## **Tom Green County**

## RFB 19-010 Hot Mix Asphalt – Burma Rd.

ADDENDUM NO 2: Notice to Bidders

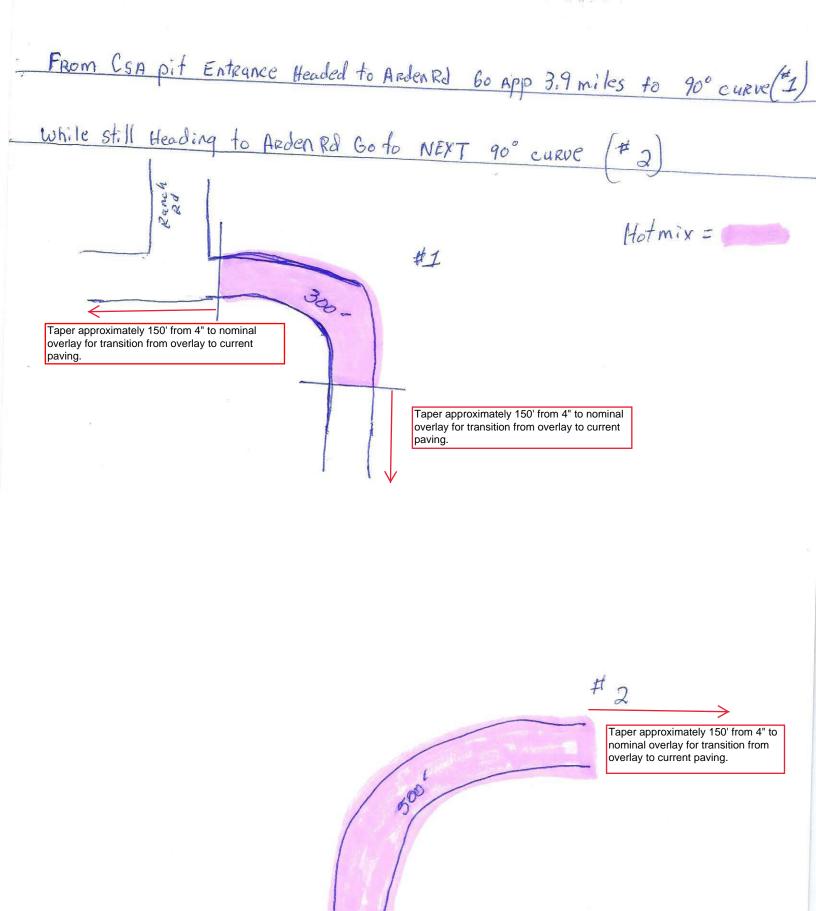
3.) If the intent is only to overlay the existing, how do you want the contractor to tie the existing paving grade to the raised paving grade?

TGC Response: Tie to existing paving grade by tapering an extended length of 150' (feet) from the 4" overlay down to current grade. Taper at low water crossing shall be an extended length of 20', but should not enter into low water crossing. (See illustrations below)
